CAR-SA

Advanced Energy United Conceptual Amendments

June 2026

Summary of Amendments

Multiple Day Event – Add Dispatchable Resources

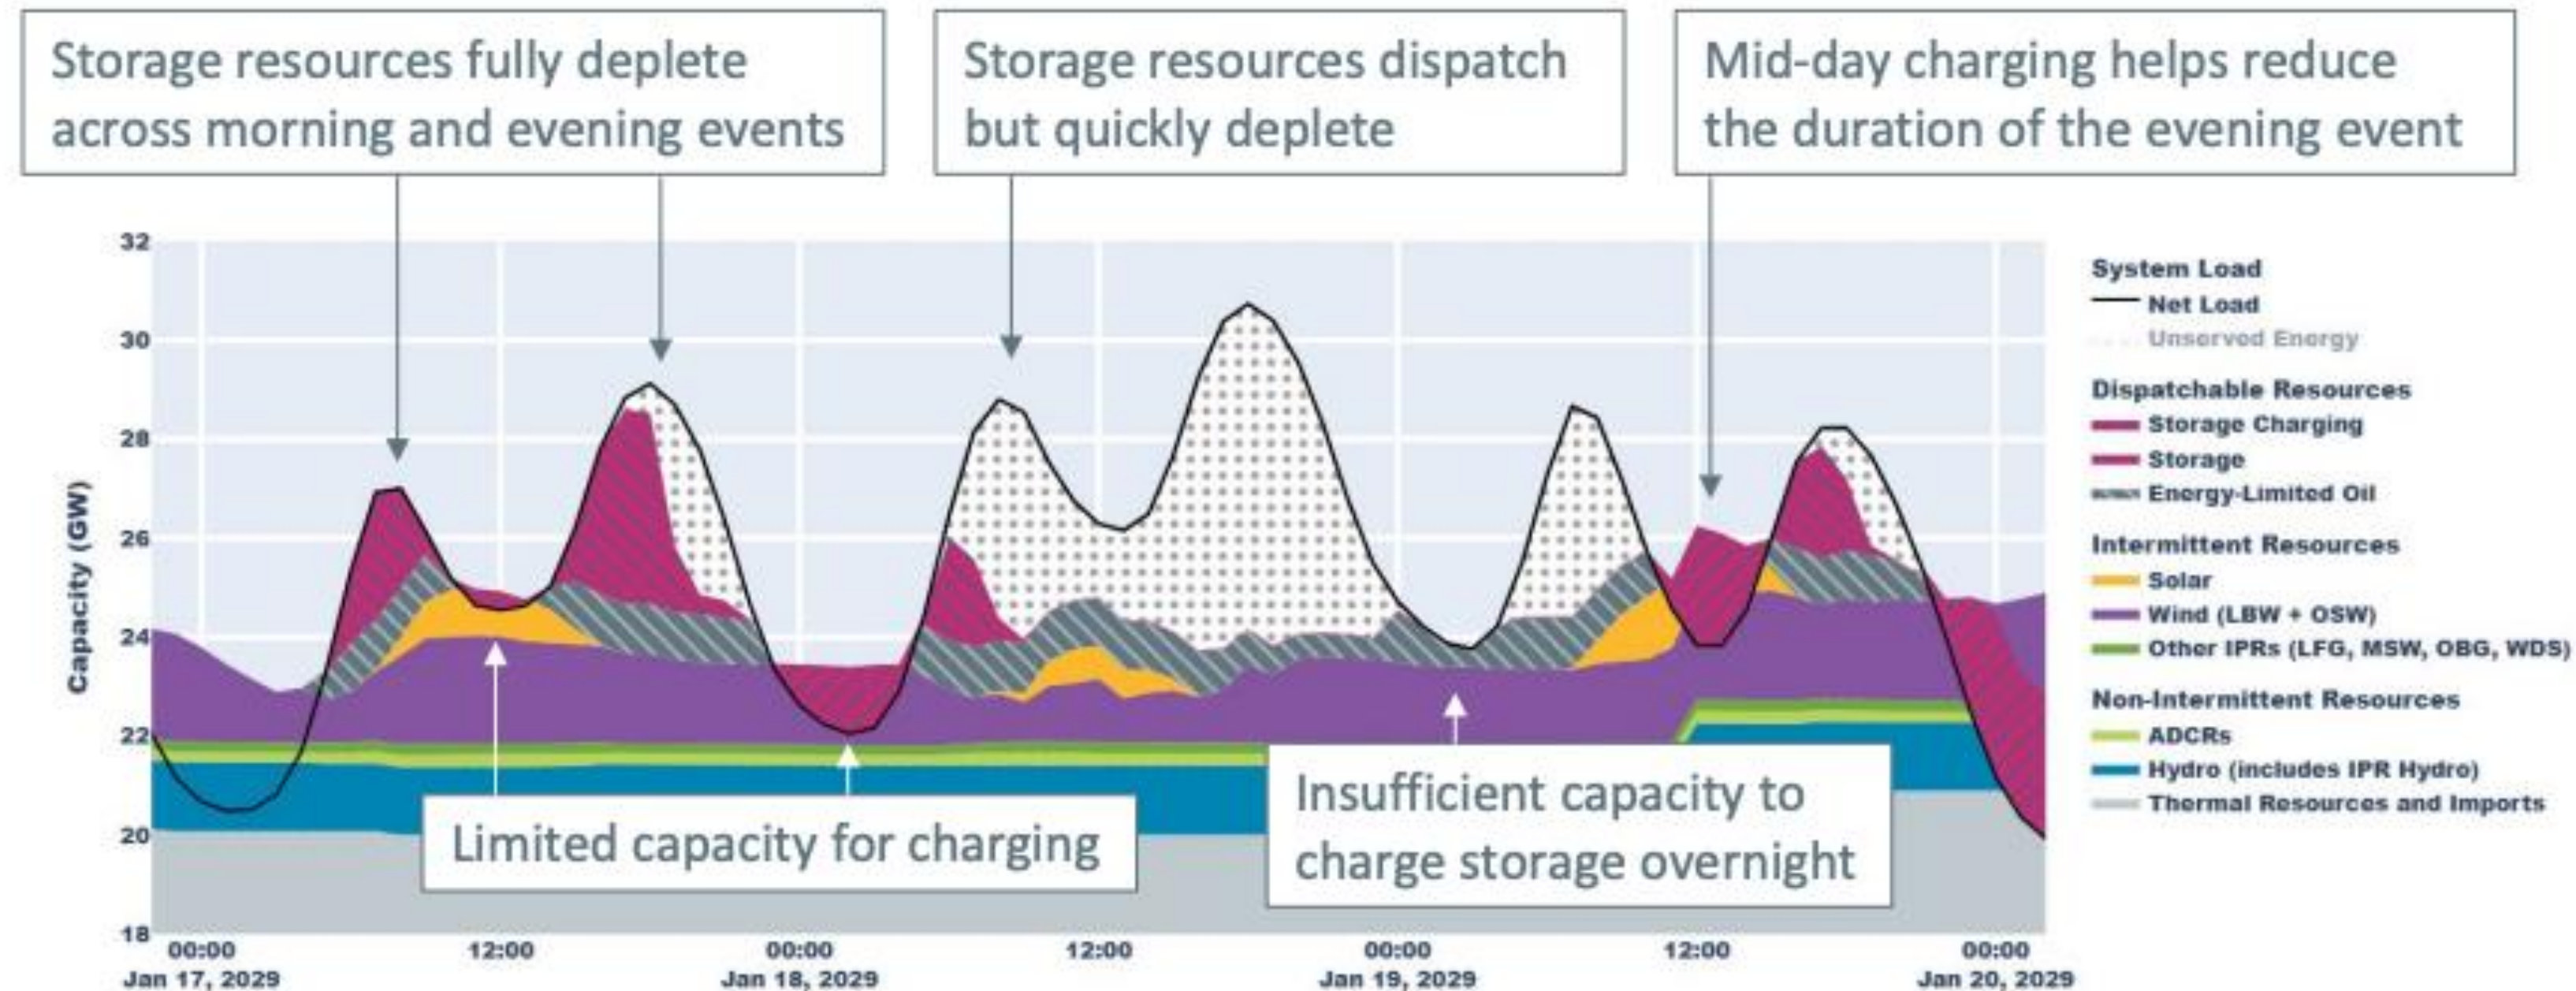
- **Model assumes flat profile:** ISO models imports as part of a 'firm' block of thermals/imports with an effectively flat profile across the day (grey wedge bottom of the graphic).
- Flattening that profile into a capacity block may obscure the hours when imports are actually available (which will often exceed the flat profile), such as overnight hours that may allow storage to recharge.

- **Conceptual amendment:** Model firm imports using the underlying *hourly import-availability profile* of the tie, aligned with load and scarcity conditions, rather than converting that profile into a flat firm capacity block that ignores when imports are actually available to serve load or support storage charging. The tie resource profile can be derived from the load shape estimated from the underlying regional system model results.

HQ Hourly Load - February 2023 Peak Example

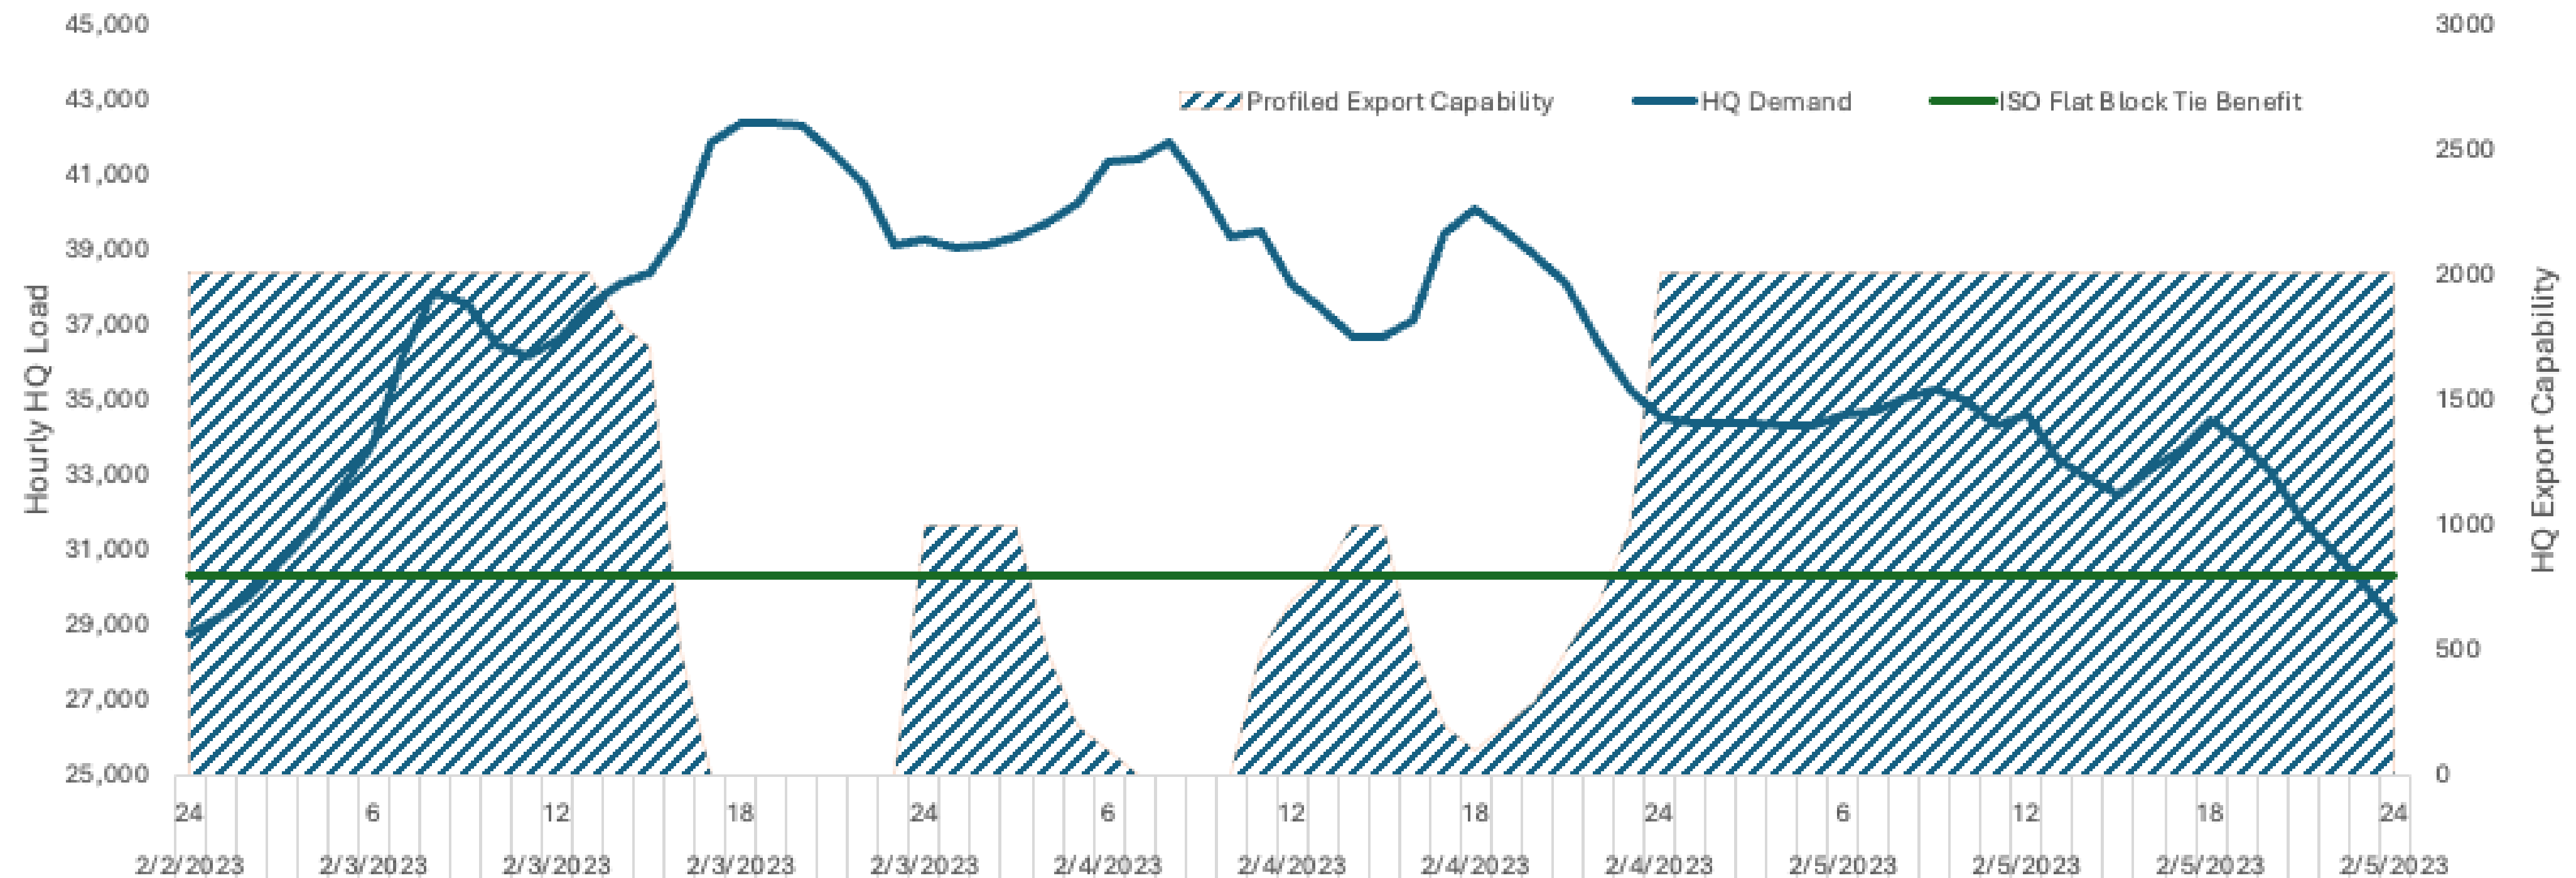
- Hydro-Québec demand is typically lower overnight, creating additional export capability during hours when storage would otherwise recharge. Note: hourly HQ export capability shown is representative, not actual, for a critical period.
- The key is that the ISO proposal converts an import shape that should have more energy available during off peak into an equivalent flat block (green line) and this underestimates energy available from the interties. The figure, a simplification, illustrates HQ would have more export capacity potential overnight.

- **ISO's proposal underestimates energy available for charging storage off-peak:** ISO's proposal converts an import shape that should have more energy available during off peak hours (striped blue shading, prior slide) into an equivalent flat block (green line) and this underestimates the available energy for charging storage. ISO's proposal also over-states the tie benefit during peak hours, widening misalignment between expected and modeled results.
